PLANT NAME: Oconee 1,2,&3

Re: Oconee Nuclear Station
Docket Nos. 50-269, -270, -287

With regard to your letters of October 14 and 15, 1975 concerning requests for additional information relative to the Oconee Nuclear Station ECCS analysis, Attachments 1 and 2 are provided.

RESPONSE TO MR. R. A. PURPLE'S LETTER

FIG. 4. (REVISED)

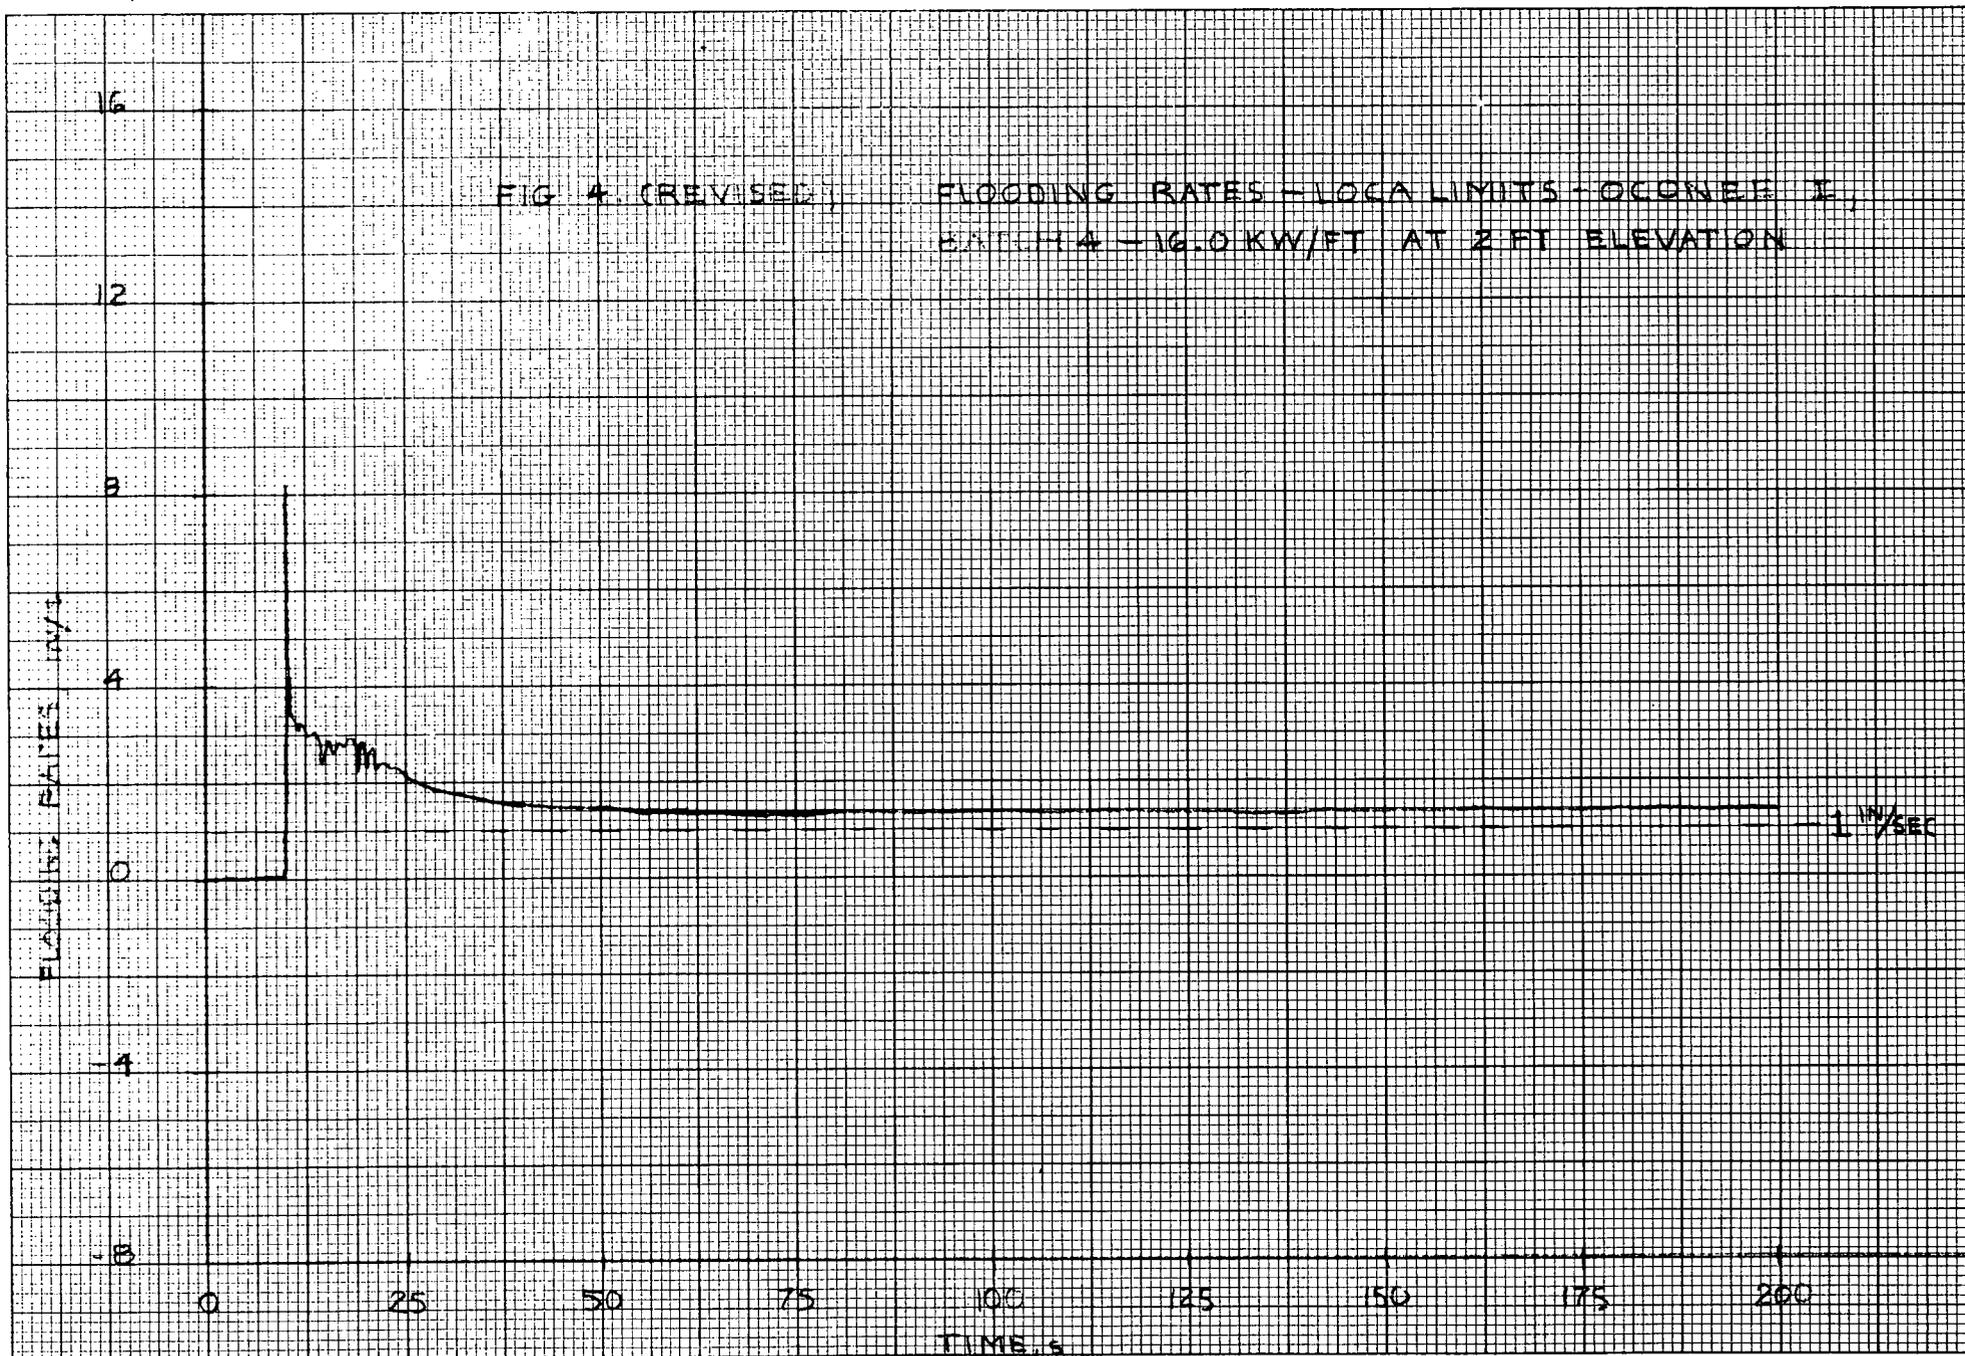
Figures 4 and 8: It is not obvious from these plots that flooding rates of less than 1 in/sec are not predicted. As indicated in the staff's "Minimum Requirements for ECCS Break Spectrum Submittals" dated April 25, 1974, resubmit these figures utilizing engineering graph paper to such a scale as to allow greater reading accuracy.

Figures 4 and 8 have been redrawn on engineering graph paper and are attached.

FIG 8 (REVISED)

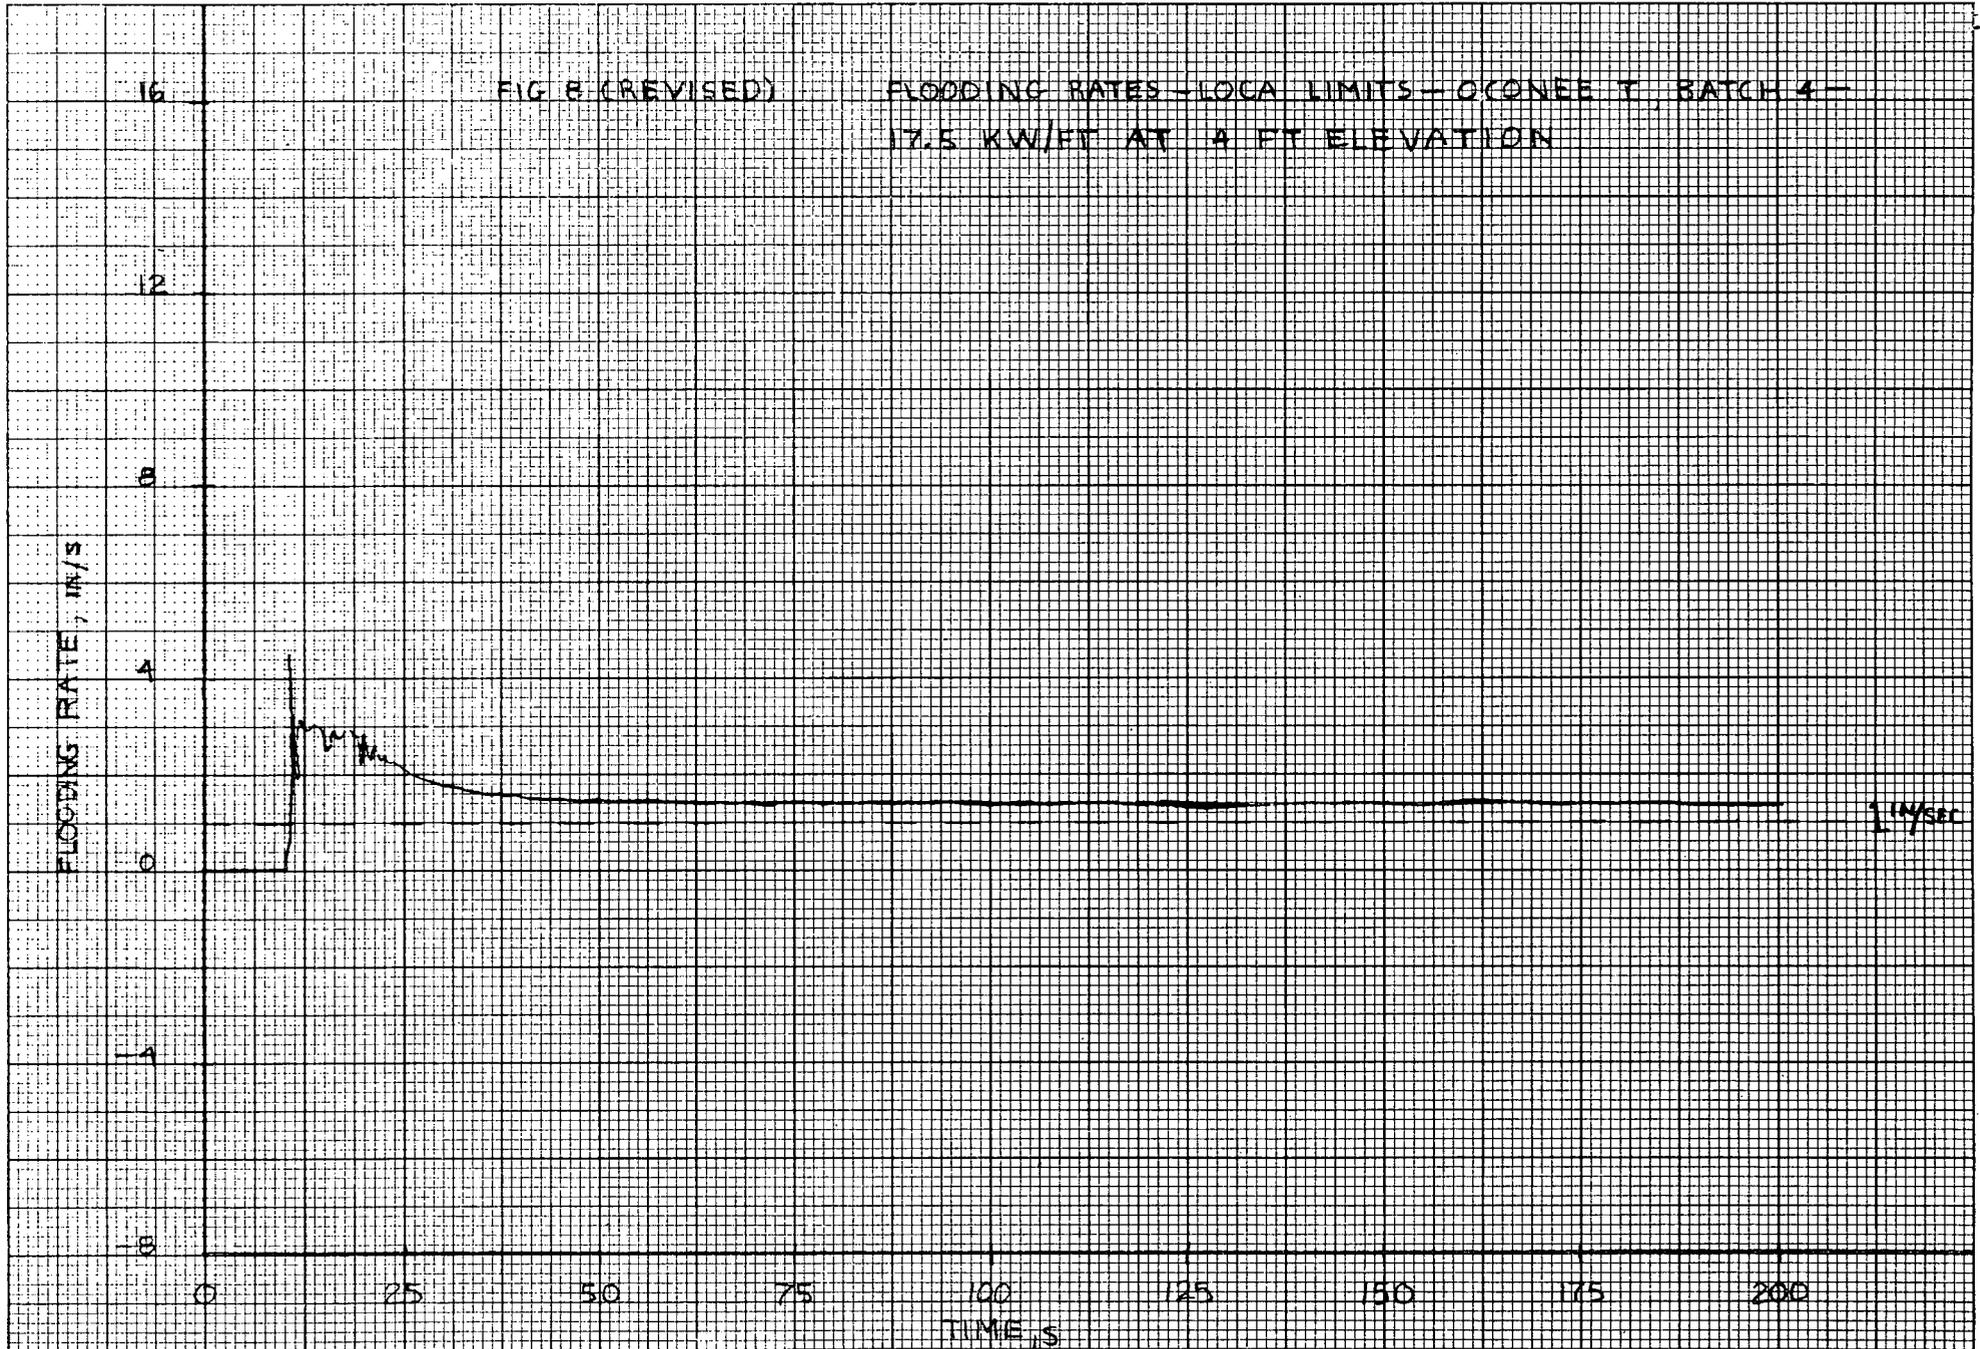
Page 9 indicated that the REFLOOD code version names are different on Figures 4 and 8. If the codes are not the same, describe the differences.

The version name associated with Figure 8, run number RF143(SY) is incorrect. Both that run and run number RF141(IV) were run on the same version of REFLOOD, i.e., REFLOOD 2 Version 2-no loop-dated 12/20/74. This has been verified by checking the actual printout of both runs.

Figure 3.5.2-1A2

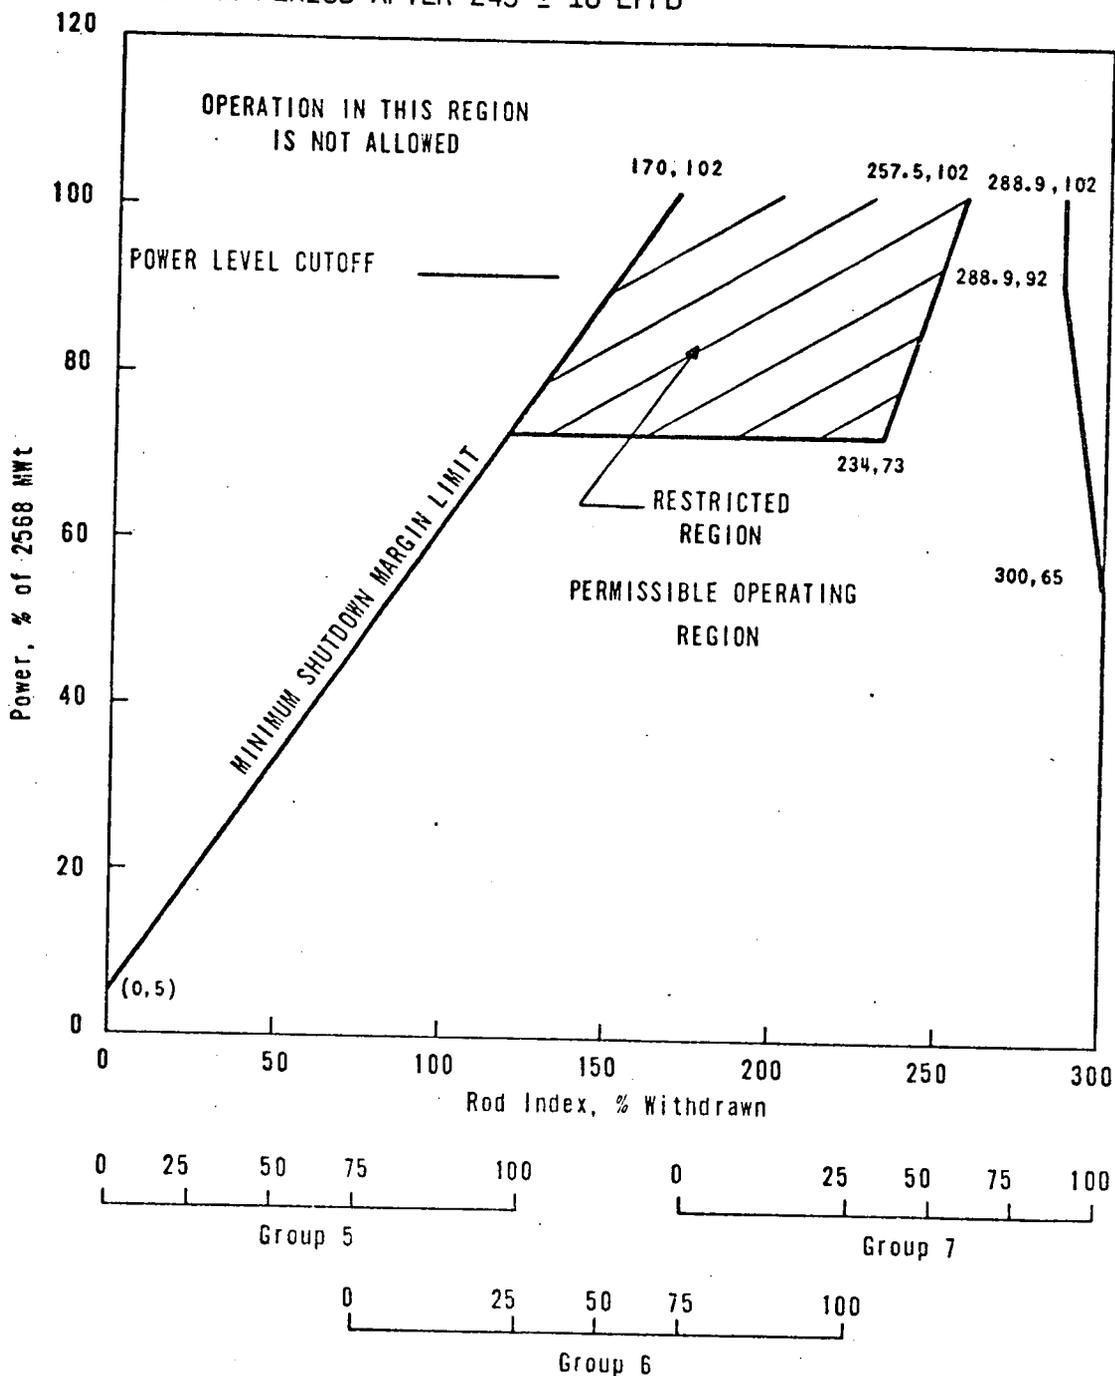
As you are aware, Amendment 6 of the Oconee Unit 1 Facility Operating License, DPR-38, revised Technical Specifications to permit operation within the appropriate fuel and core design limits during the second fuel cycle. The proposed control rod withdrawal limit for four-pump operation (Figure 3.5.2-1A2) after 250 ± 5 full power days of operation was not included. The omission of this curve was due to the expected approval of Technical Specifications based on the ECCS Final Acceptance Criteria before the curve would be required. On July 9, 1975, an analysis of Oconee ECCS performance using an approved evaluation model was submitted. This submittal included revised control rod withdrawal curves for Oconee 1 Cycle 2 operation.

Currently, Oconee Unit 1, Cycle 2 measured boron concentration data indicate that it may be necessary to begin removal of the Group 7 control rods from the core as early as 235 EFPD, rather than the originally estimated 245-255 EFPD. The associated small discrepancy, approximately 20 ppmB, between the measured and the predicted boron concentration at this core lifetime, is well within the tolerance of calculational uncertainties. In order to assure the continued full power operation of Oconee 1, revised Final Acceptance Criteria control rod position limits and operational power imbalance envelopes have been prepared which permit withdrawal of Group 7 control rods 245 ± 10 EFPD

(in lieu of 250 ± 5 EFPD proposed in July 9, 1975 submittal). Therefore, pursuant to 10CFR50, §50.90 and the provisions of the Commission's December 27, 1975 Order for Modification of License for Oconee Nuclear Station, Units 1, 2, and 3, it is requested that the control rod position limit and operational power imbalance envelope described in Attachment 3 be approved prior to attaining 235 EFPD on Oconee 1. Presently, with expected capacity factors, it is estimated that this will occur on November 28, 1975.
